**LYNWOOD QUARRY
EXTRACTION AREA
MODIFICATION
(MOD 4)**

Response to Submissions

February 2016

Prepared by
Umwelt (Australia) Pty Limited
on behalf of
Holcim (Australia) Pty Limited

FIGURE 1.3

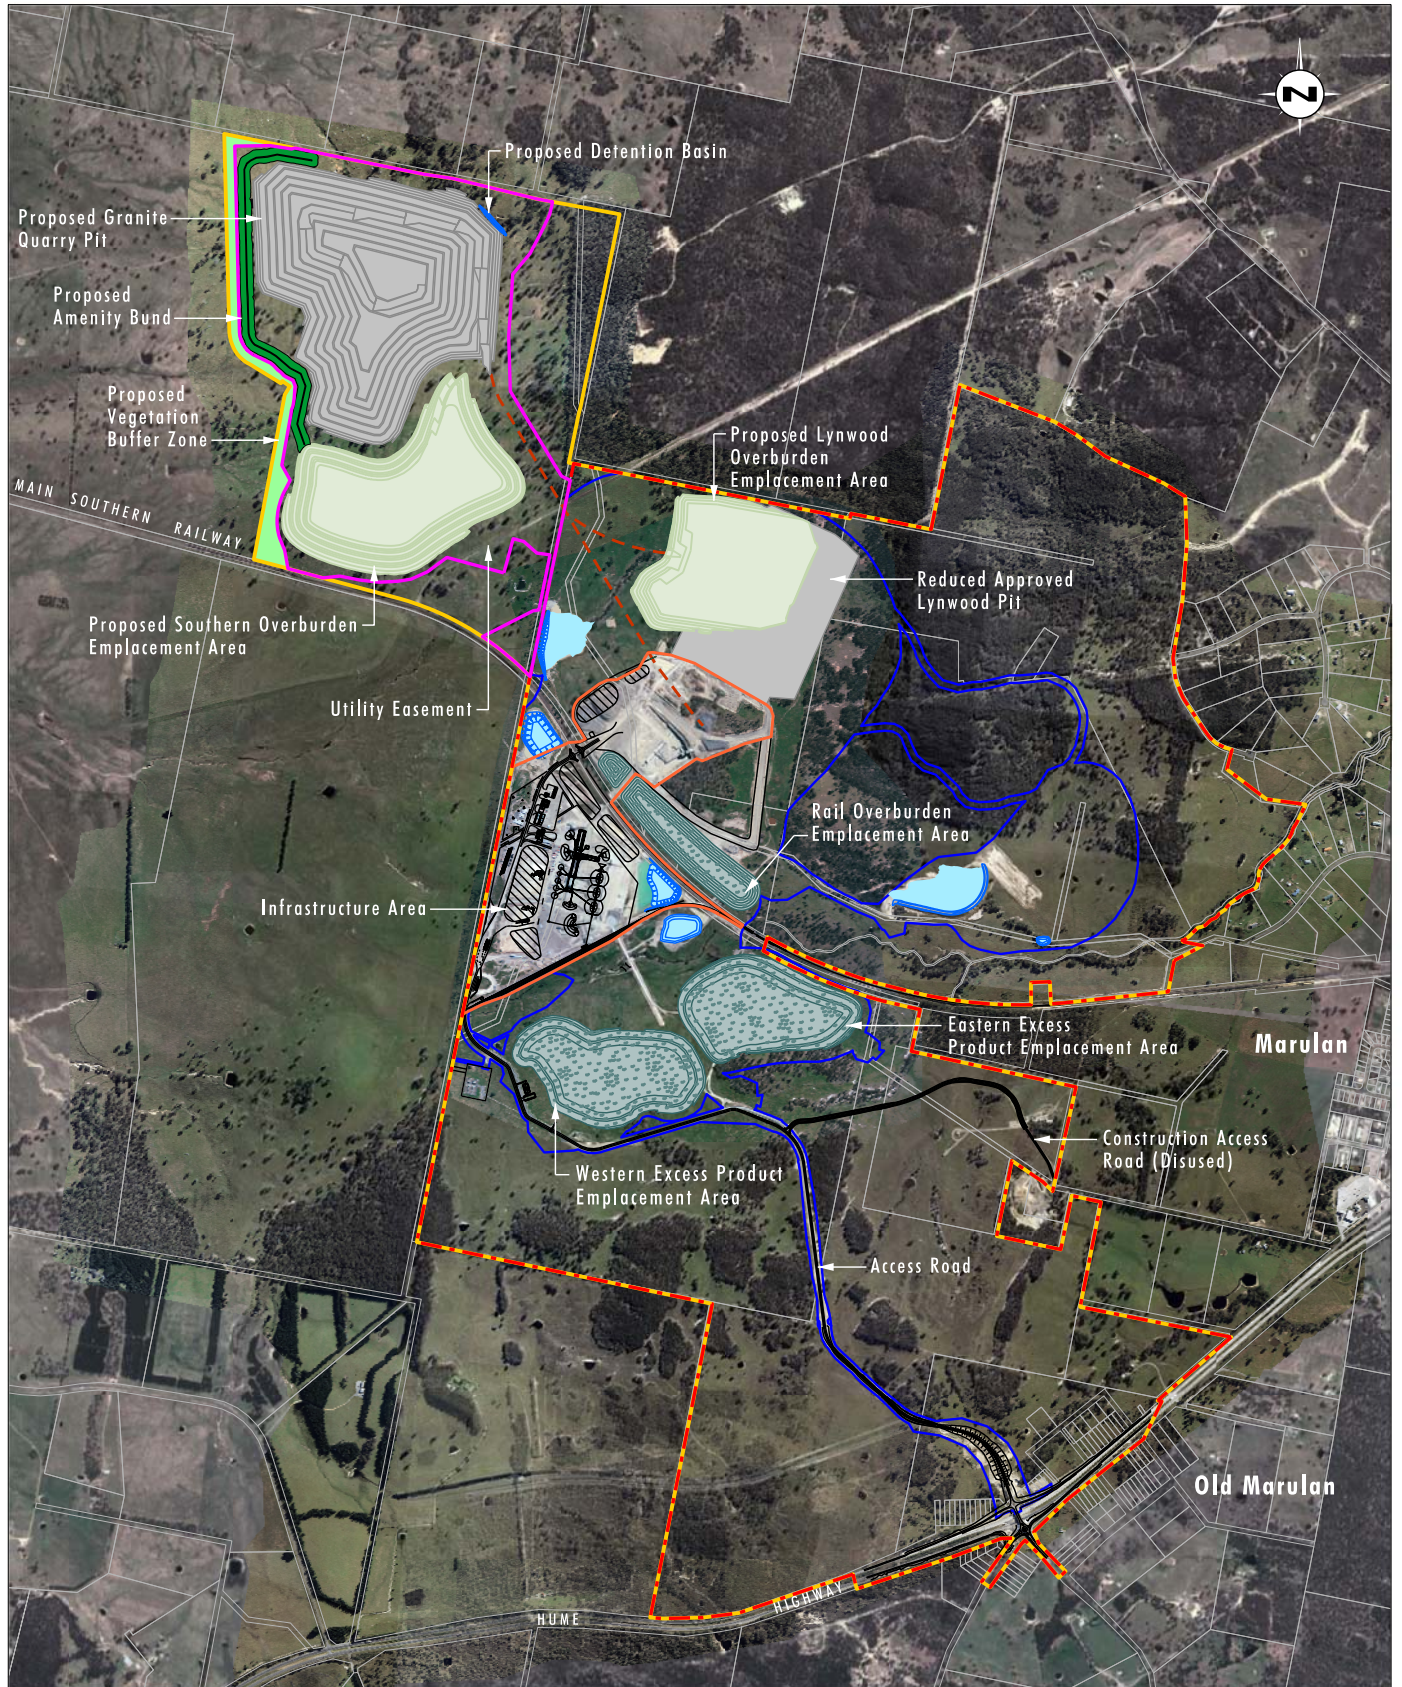
Issued Raised	Response
Granite Pit Site	
<i>Our property and residence are east of both the Approved Pit and the Granite pit and will be directly exposed to the revised overburden emplacement areas and additional haul roads. (Figure 1.3) but will not have the protection of any amenity bunds.</i>	It is noted that the residence associated with the submission is located to the northeast of the Granite Pit Area and that it is correct that the amenity bund proposed to be located to the west and northwest of the Granite Pit is not of benefit to their residence. However, due to the natural topography, there is a ridge and heavily vegetated area between the Granite Pit and all of the residences to the northeast which will be effective in screening the operations. The Granite Pit Area will not be visible from residences to the northeast and the ridge line will also be effective in mitigating the potential for noise impacts.

FIGURE 2.1
Plan of Existing and
Proposed Sediment Dams

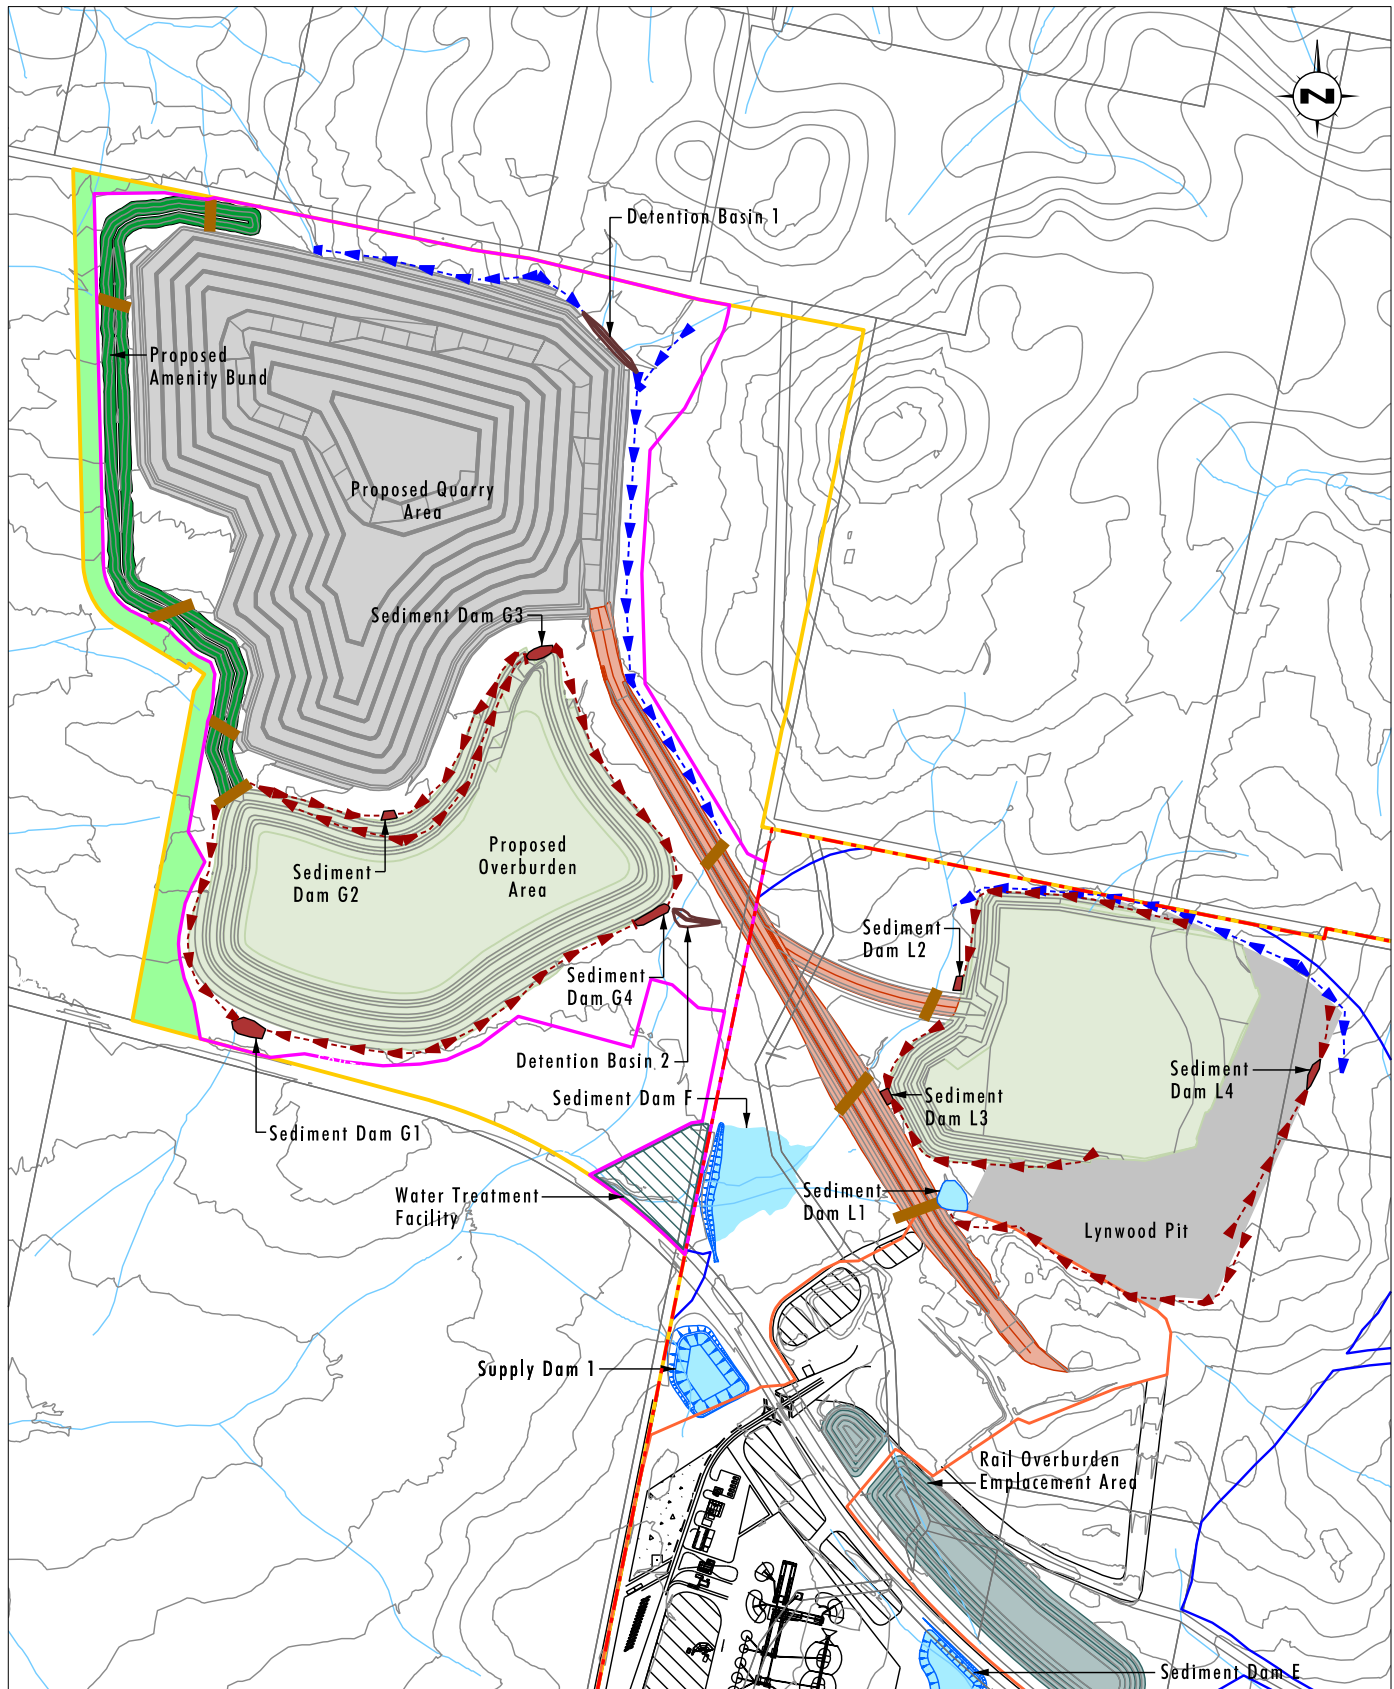
It is recommended that the 95th percentile 5-day rainfall depth of 40.8mm should be used in Sediment basin designed and be addressed as part of the updated Water Management Plan.

The proposal requires the transfer of water between dams and water management structures on the site. To ensure that this is achievable and pollution events do not occur, the site must have adequate pumping / infrastructure / staffing capacity to achieve the desired outcomes and this should be addressed as part of the updated Water Management Plan.

Holcim Australia acknowledges that the quarry site is located within the Sydney drinking water catchment and upstream of the Marulan town water off take on the Wollondilly River. Holcim Australia accepts Water NSW's recommendation that the new sediment dams related to the Modification Project (i.e. Dams G1, G2, G3, G4, L2, L3 and L4, refer to **Figure 2.1**) are constructed to manage the 95th percentile 5 day rainfall depth of 40.8 millimetres. The design capacities of the additional dams related to the Modification Project, taking into consideration the design rainfall depth change for the sediment dams are shown in **Table 2.1** and will be included to this design standard in the updated Water Management Plan.

It is noted that this design criteria will only apply to the new sediment dams proposed as part of the Modification Project, with the existing design criteria of the 90th percentile 5 day rainfall event remaining in place for the existing and approved dams at Lynwood Quarry.

Holcim Australia is currently undertaking the detailed design for the pumping/pipeline systems for the Modification Project. The design pumping capacity will be sufficient to meet relevant Blue Book (*Managing Urban Stormwater: Soils and Construction, Volumes 1 and 2*, Landcom, 2004 and DECC, 2008) design requirements, for example, the ability to pump out the sediment dams to provide the required freeboard in the design period (i.e. 5 days adopted as per **Table 2.1** above).

FIGURE 2.2

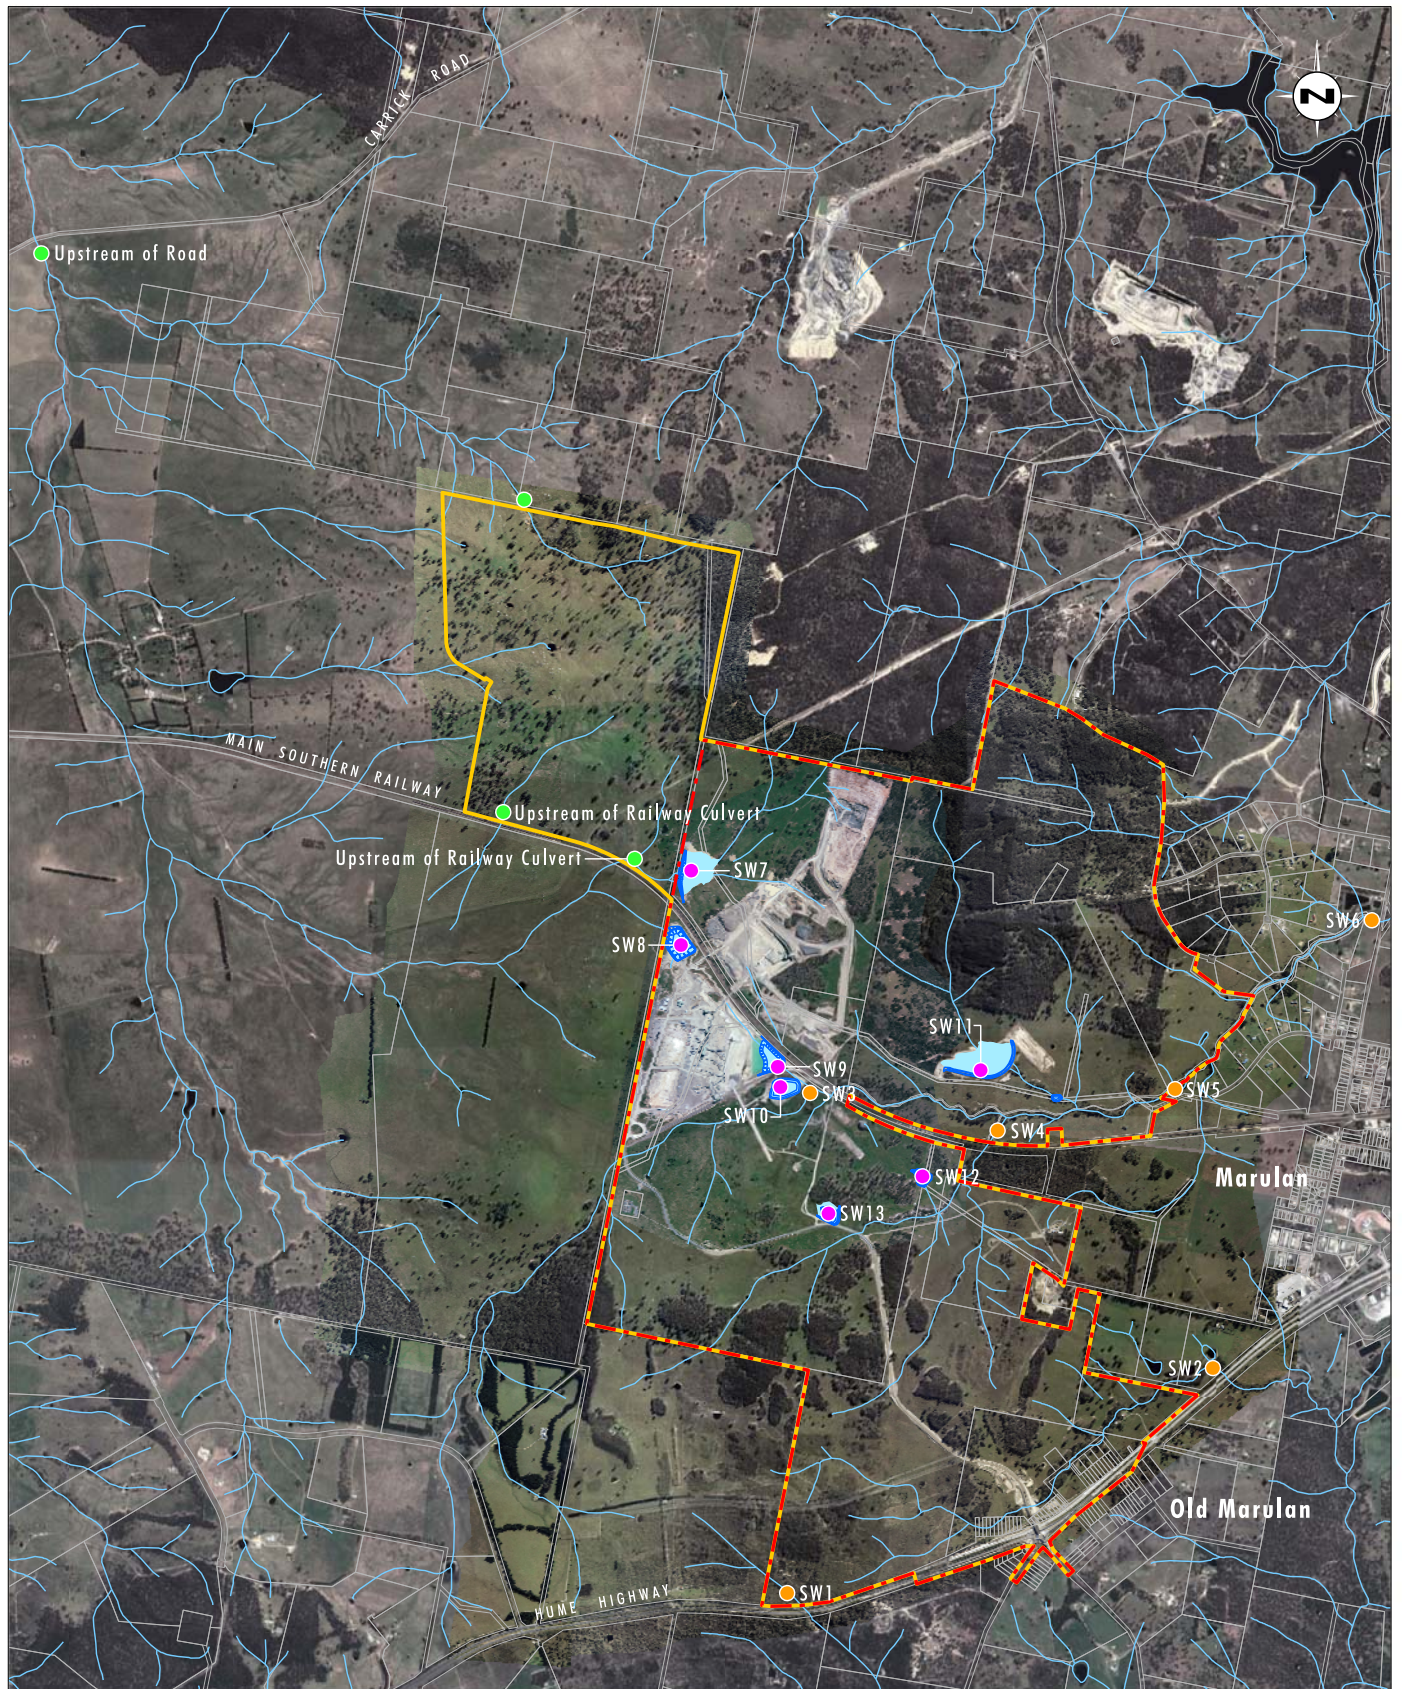
Adequate surface water and groundwater monitoring data should be collected on the granite resource site and the Lockyersleigh Creek catchment prior to commencement of the modification development. WaterNSW recommends there be an additional surface water monitoring site on the northern boundary of the western extension area noting that the watercourse is a third order stream at this location.

In regard to surface waters, three new surface water quality monitoring sites were proposed in the Surface Water Assessment within the Lockyersleigh Creek catchment area (refer to **Figure 2.2**). In response to the WaterNSW comment suggesting an additional water quality monitoring site on the northern boundary of the western extension area (i.e. on the third order watercourse), Holcim Australia agrees to include this location as an additional surface water quality monitoring site. The additional, i.e. 4th monitoring point, on Lockyersleigh Creek is also shown on **Figure 2.2**. The final details of the proposed surface water monitoring program will be contained within the updated Water Management Plan.

FIGURE 2.4

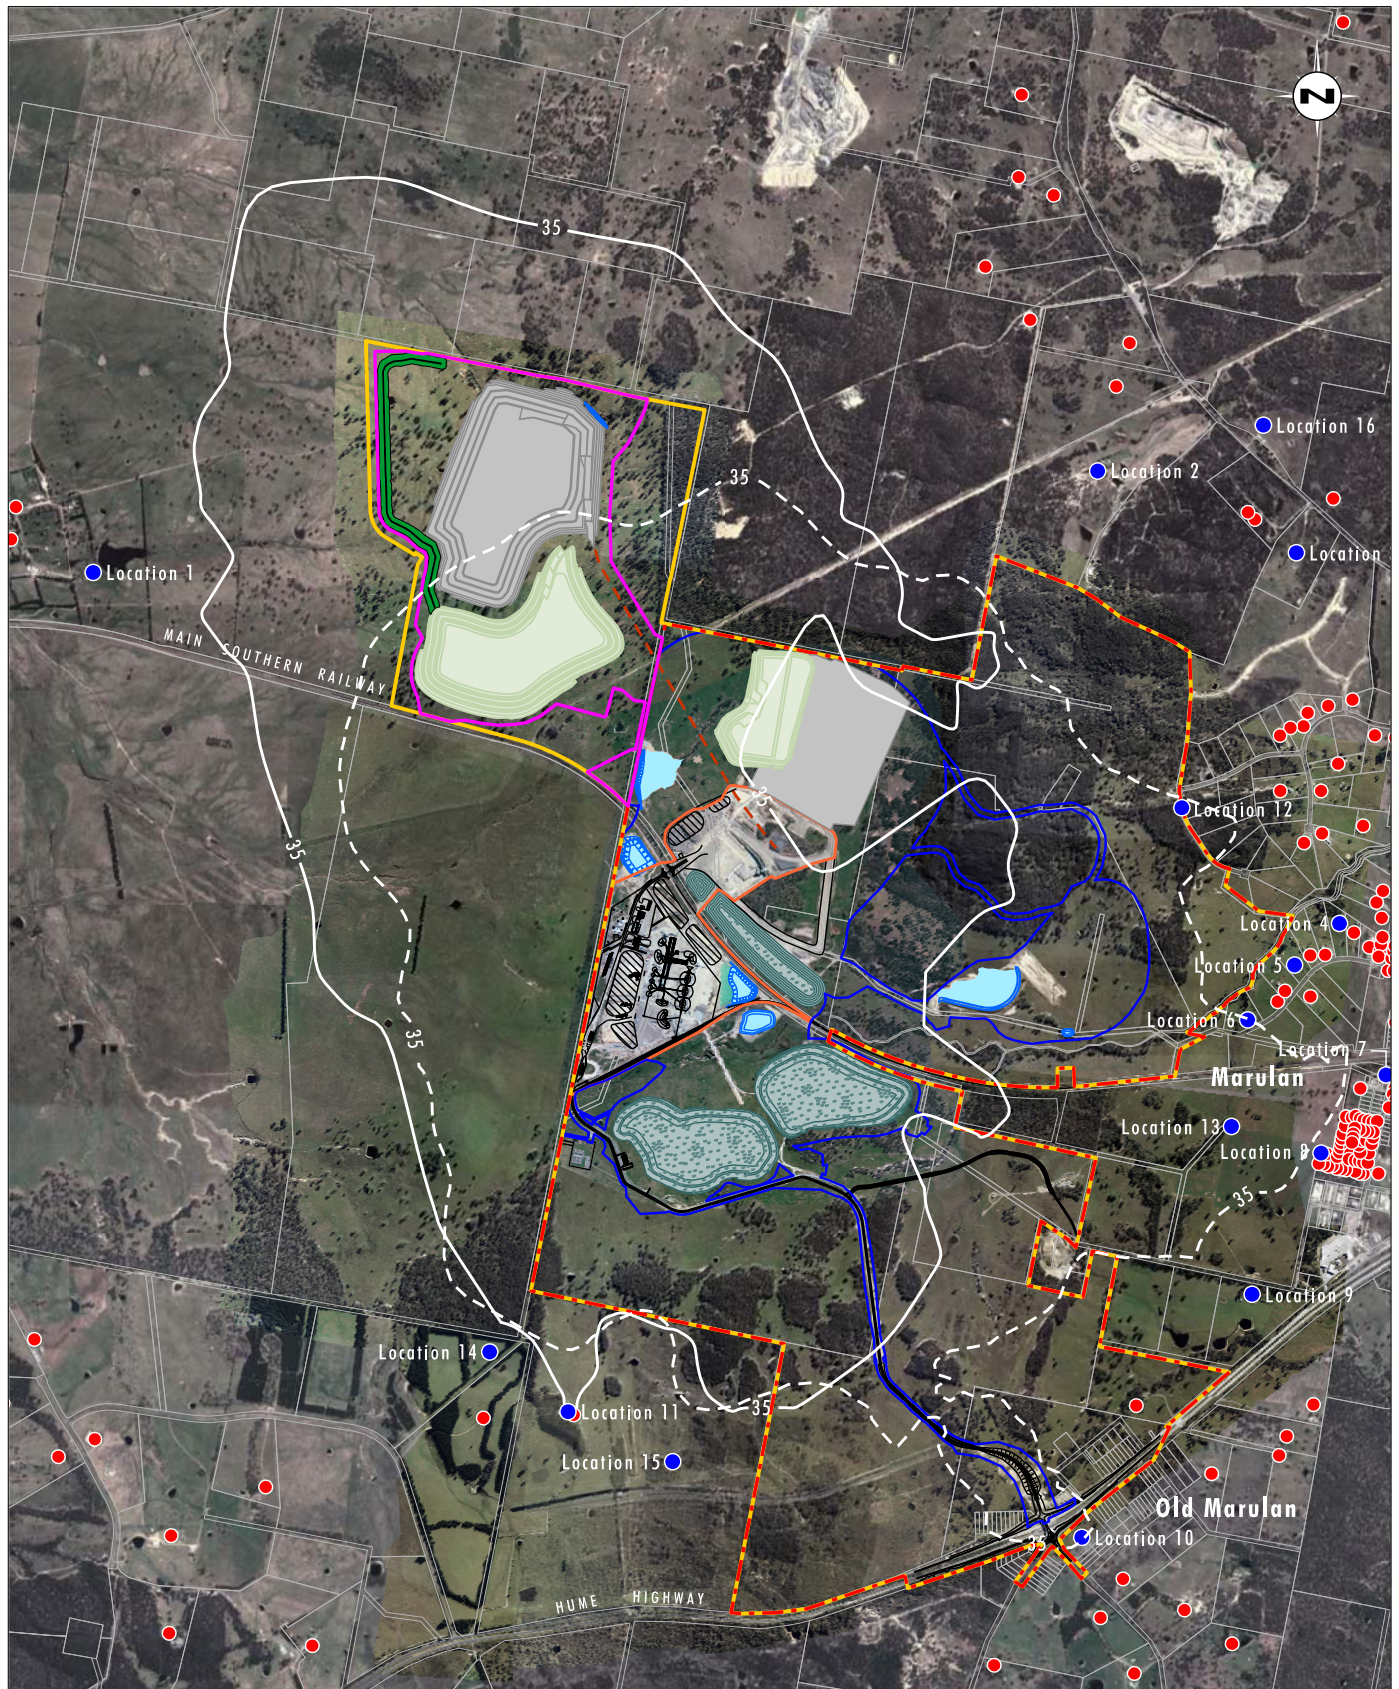
The EPA generally accepted the results and conclusions of the noise assessment and has indicated that it is satisfied that the Modification Project will not have any adverse noise impacts on the environment. The EPA accepted the proposed increased noise criteria at Location 11 from 35dB(A) to 36dB(A) and advised the following:

- (a) Negotiate a Pollution Reduction Program with Holcim to conduct noise monitoring to validate the predicted noise impacts under the operational conditions at Location 11; or***
- (b) Recommend such a noise validation is undertaken as a condition of any modified development consent.***

As defined in Section 6.3.3 of the EA, with respect to Receiver Location 11 (refer to **Figure 2.4**), future operations at Lynwood Quarry were predicted to be unable to achieve the approved noise criteria of 35dB(A) during the night time periods (10 pm to 7 am) due to the inclusion of a night time easterly wind assessable under the INP (EPA, 2000). It is noted that this outcome is not due to the Modification Project, as no changes to the approved night-time operations are proposed, with only the approved processing and product delivery activities occurring during the night-time period (i.e. as part of the Approved Operations). This change in predictions is due to the inclusion of the night-time easterly wind condition in the noise modelling via an update to the previous noise models for Lynwood Quarry using local meteorological data collected on the Lynwood Quarry site.

As the pre-existing consent criteria for Receiver Location 11 (35dB(A)) were less than the project specific noise levels (PSNLs) calculated in accordance with the NSW Industrial Noise Policy (INP) (EPA, 2000), new criteria were developed for Receiver Location 11 in accordance with the INP. The proposed LAeq,15minute night time noise at criteria Receiver Location 11 is 36 dB(A), 1 dB below the original night time PSNL for the location. As the predicted noise impacts meet the PSNL for Receiver Location 11, the noise impacts at this location are considered acceptable under the INP.

In accordance with recommendation (b) of the EPA submission regarding a noise validation program, Holcim Australia agrees to continue noise monitoring at Location 11 as part of the implementation of the development.
